COUNCIL PANEL SUPPLEMENTARY ASSESSMENT REPORT

Panel Reference	2017SNH084
DA Number	DA0610/17
LGA	Ku-ring-gai
Proposed Development	Demolition of existing structures and construction of a mixed use development comprised of shop top housing containing 56 apartments, use of ground floor commercial space as an Aldi supermarket and small retail suite, basement parking, signage and associated works
Street Address	810-818 Pacific Highway, Gordon
Applicant/Owner	RPS Group / Pacific Highway Gordon P/L & Ku-ring-gai Council
Date of DA Lodgement	11 December 2017
Number of Submissions	7 submissions in response to 1 st notification, 1 submission in response to notification of amended plans
Recommendation	Refusal
Regional Development Criteria (Schedule 7 of the SEPP (State and Regional Development) 2011)	CIV in excess of \$20 million Works on land to which Council has an interest in excess of \$5 million
List of all relevant s4.15(1)(a) matters	<ul style="list-style-type: none"> • SEPP 55 – Remediation of Land • State Environmental Planning Policy No. 64 • State Environmental Planning Policy No. 65 • SEPP (Infrastructure) 2007 • State Environmental Planning Policy (BASIX) • Sydney Regional Envir

Figure 1

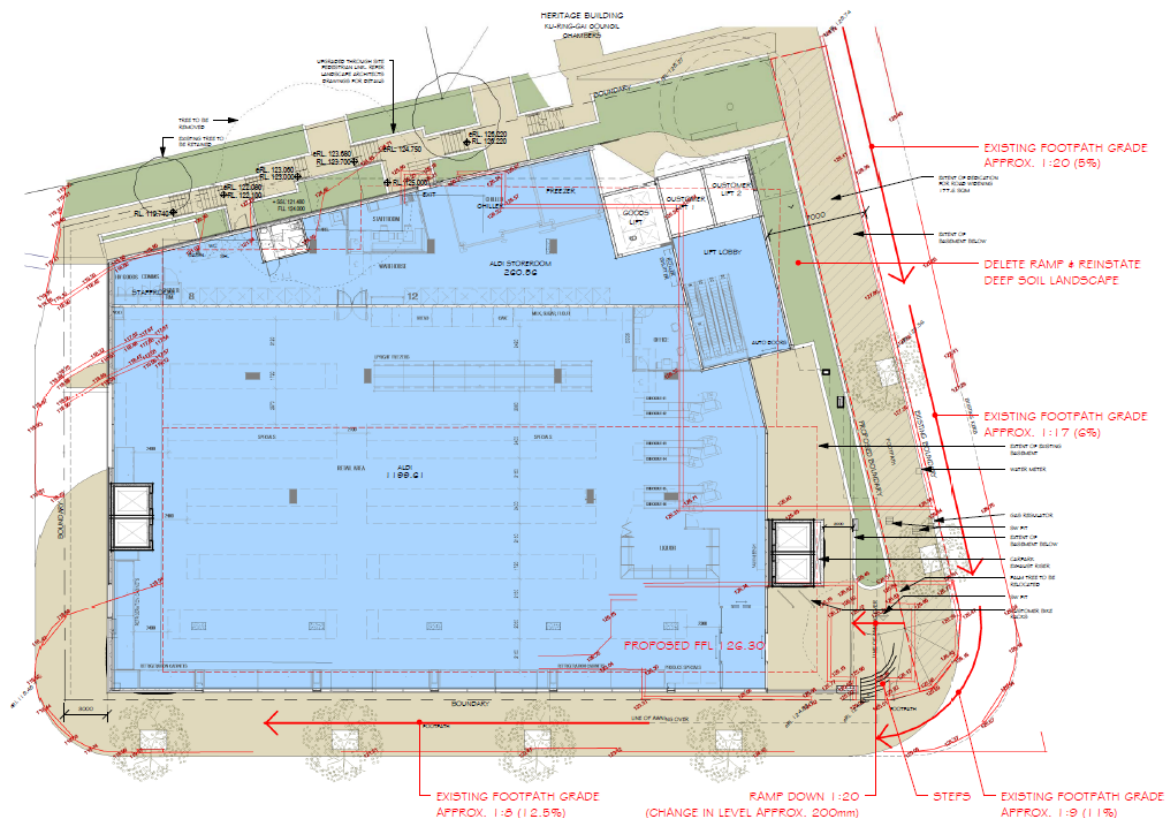
Amended plan raising the ground floor level by 600mm, deleting the ramp to the supermarket from the street and altering the access courtyard at the corner of Pacific Highway and Dumaresq Street.

Figure 4

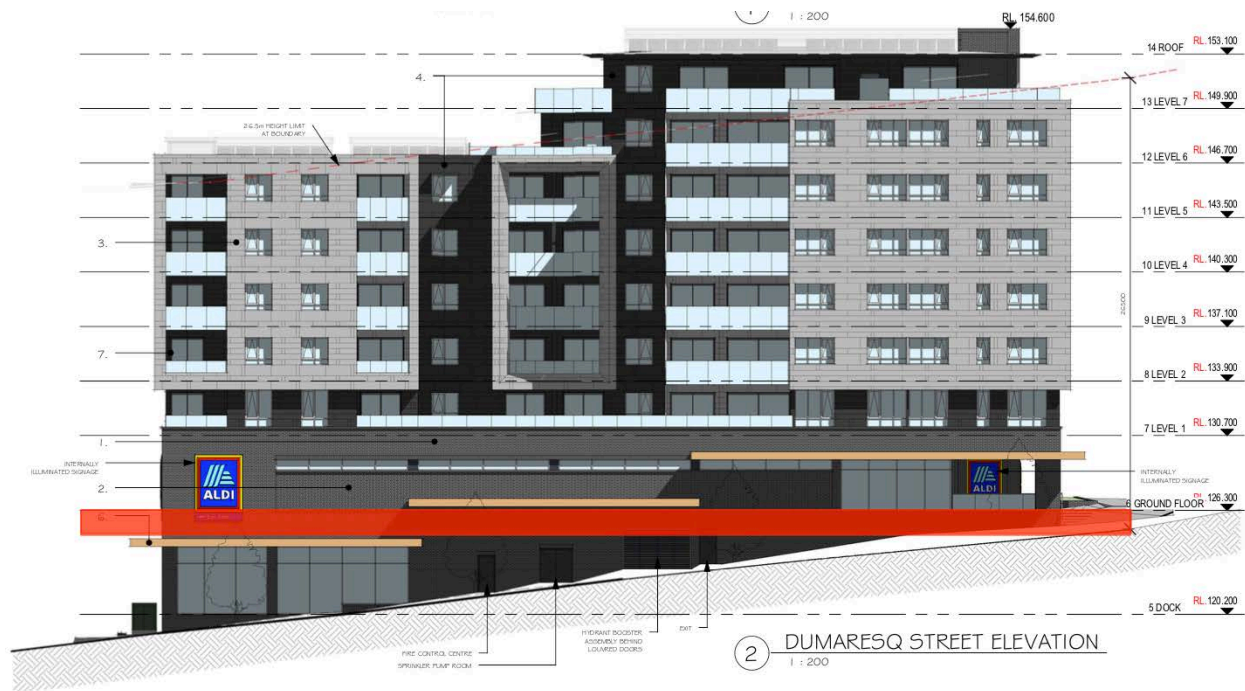
In addition, the volume and height of the building is exacerbated by the dock level which has a floor-to-floor height of 6.1 metres but does not contribute to gross floor area (due to the LEP definition) even though its volume is largely above ground level (towards the rear of the building).

Dumaresq Street elevation [DA14E] showing the additional 1.6m height in red that the dock level contributes to the building over and above what it needs to operate.

Figure 5

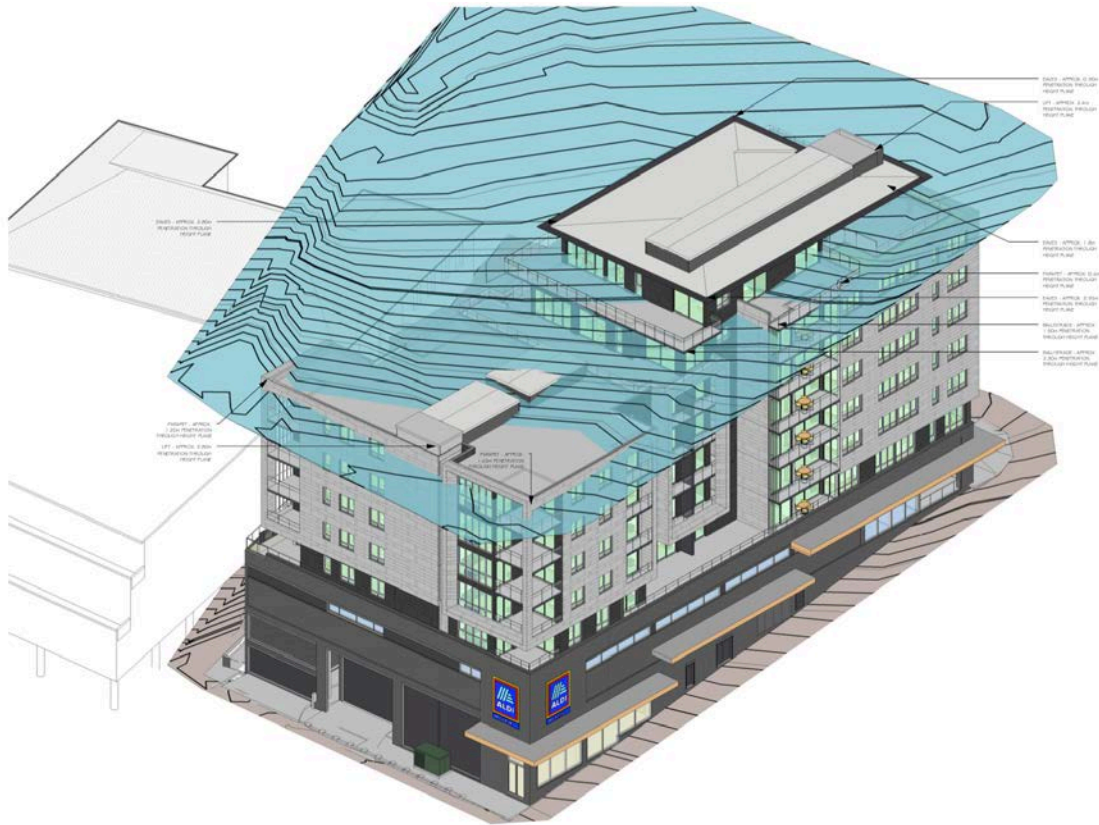
Given the extent of the overrun at almost two full residential storeys in height, it is considered that the topmost floor should be removed. This would leave only more minor encroachments of the height plane such as those that occur at level 5. Alternatively, a planning proposal could be submitted to vary the LEP maximum building height for the site.

Height plane study [DA22E] showing most of the volume of the top floor breaking through the height plane. Note that downwards view reduces apparent exceedance.

Figure 6

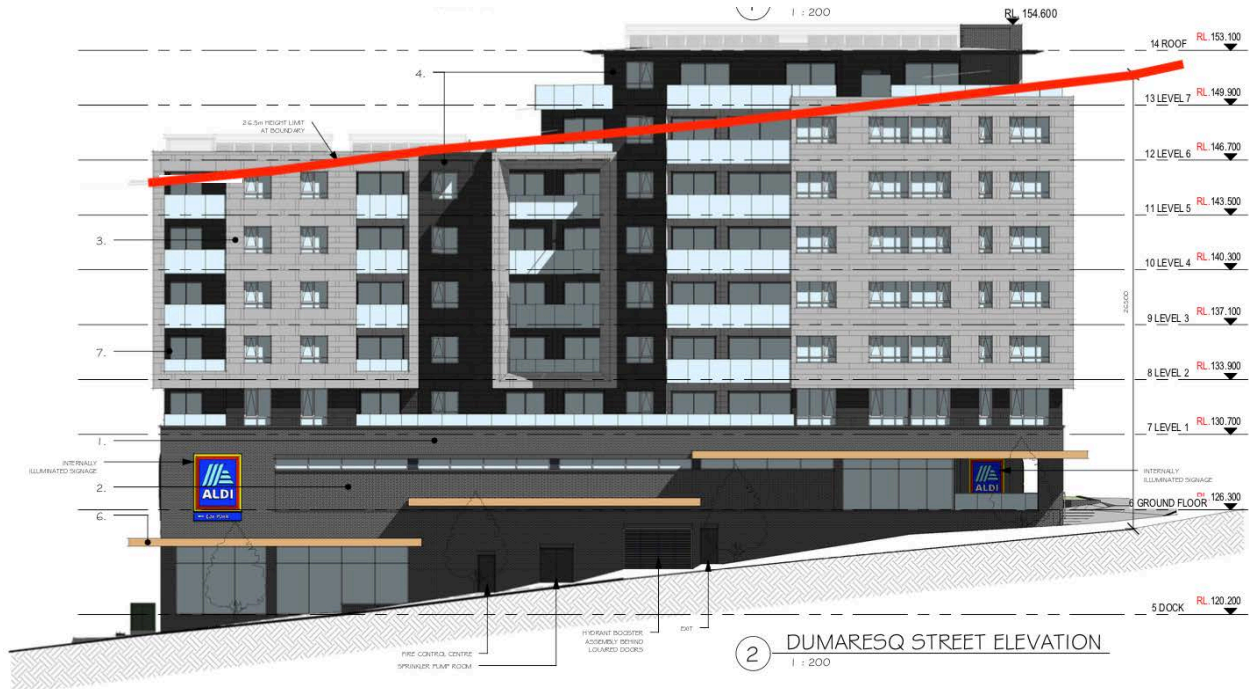
Dumaresq Street elevation [DA14E] with height plane highlighted showing most of the volume of level 7 above the height plane. Note that other elevational views appear to show the height plane at the boundary rather than at the face of the building and are therefore not accurate indications of height breach.

Thirdly, it cannot be said that the breach of the height plane 'enables' the building to respond to the topography 'appropriately'. This might be said of small encroachments to the height plane, however

in this instance where there are large encroachments of the height plane of greater than an entire residential floor-to-floor height, the appropriate, or 'reasonable', way to respond to the steep slope of the site is to remove the topmost floor of the building (Level 7).

Figure 16

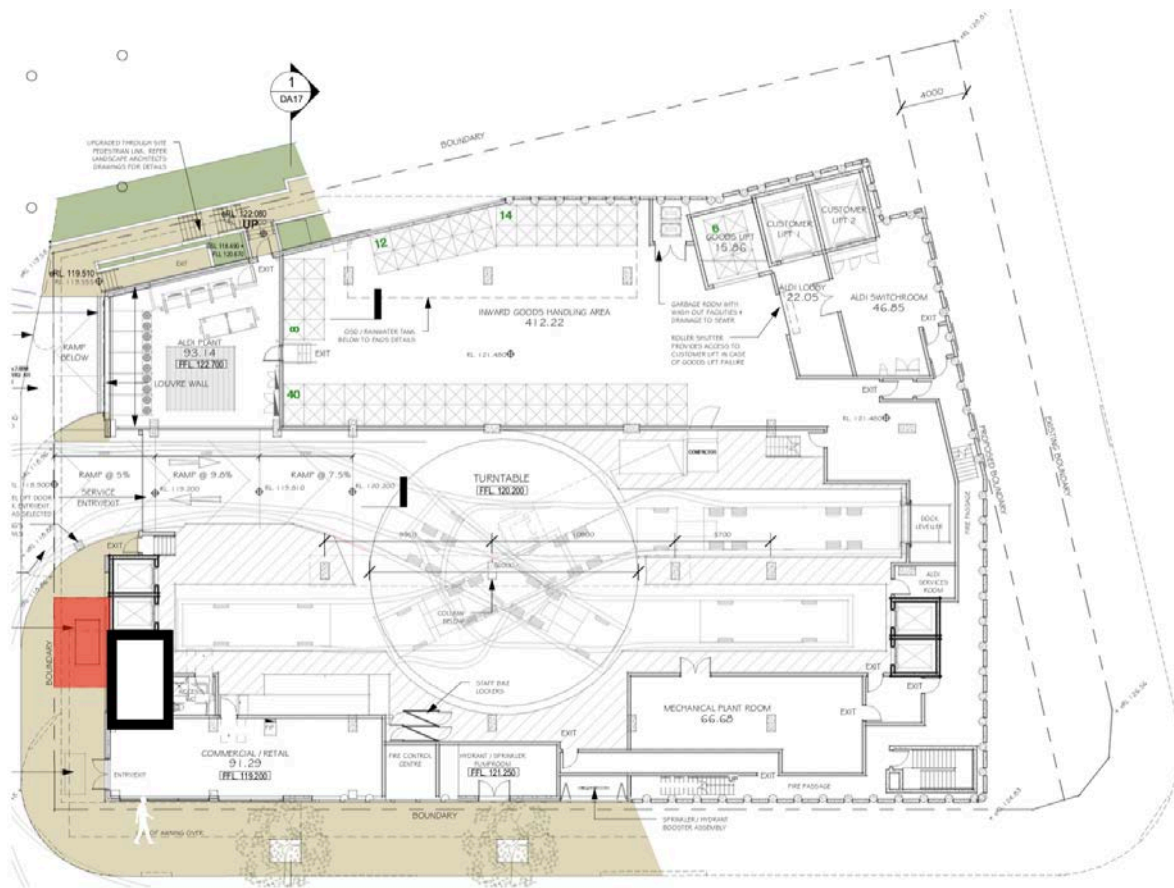
Whilst it is possible to locate the substation in the centre of the footpath that is to be dedicated to Council at no cost (Part 14D.9 7(vi)), it is not desirable. This location will have a negative impact on the public domain. The substation should be incorporated within the final boundary of the site. A suitable location appears to be available on the southern side of the western lift. The high floor-to-ceiling height of the dock level appears to provide adequate clearance for service of the substation and provision of adequate structure to protect from any additional blast.

Loading Dock plan [DA04F] showing proposed location of substation in red and suggested location outlined in black.
